SAFETY RECALL NOTICE

Re: Brake Pedal Connecting Rod Pins Replacement

Campaign no.: 2010-0014

April 16th, 2012Subject: **Spyder™ RT Brake Pedal Connecting Rod
Pins Replacement**No. **2010-11**

ORIGINAL RETAINING PINS TO BE REPLACED

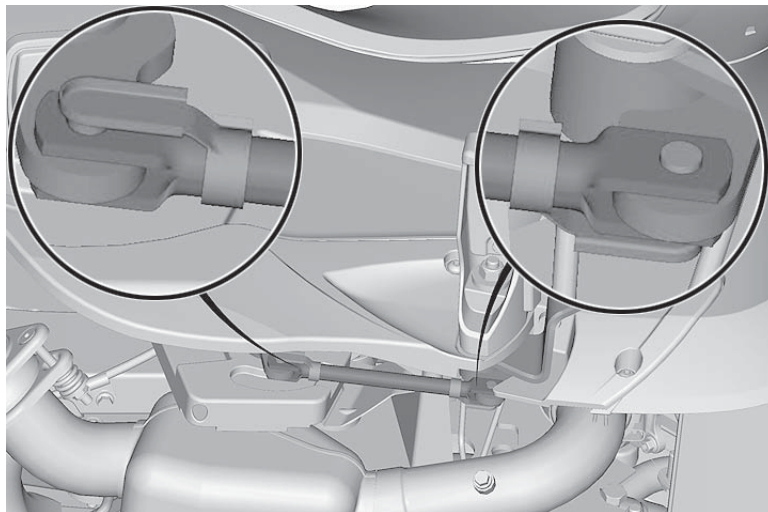
A pin securing the brake pedal connecting rod could disengage and eventually fall off.

This could cause a total loss of main brake function without prior warning. This condition may increase the risk of a crash possibly resulting in injury or death.

Replace **both** brake pedal connecting rod retaining pins as follows.

Replace the brake pedal connecting rod retaining pins.

NEW RETAINING PINS PROPERLY INSTALLED

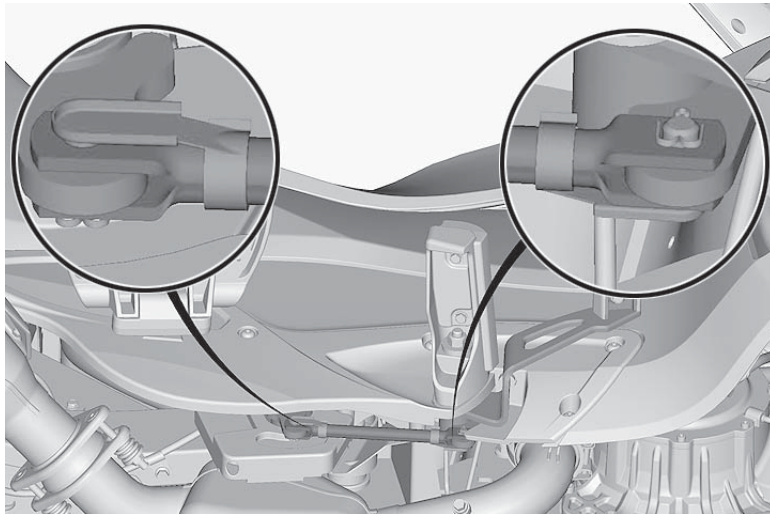
IMPORTANT: Replace **both** retaining pins.
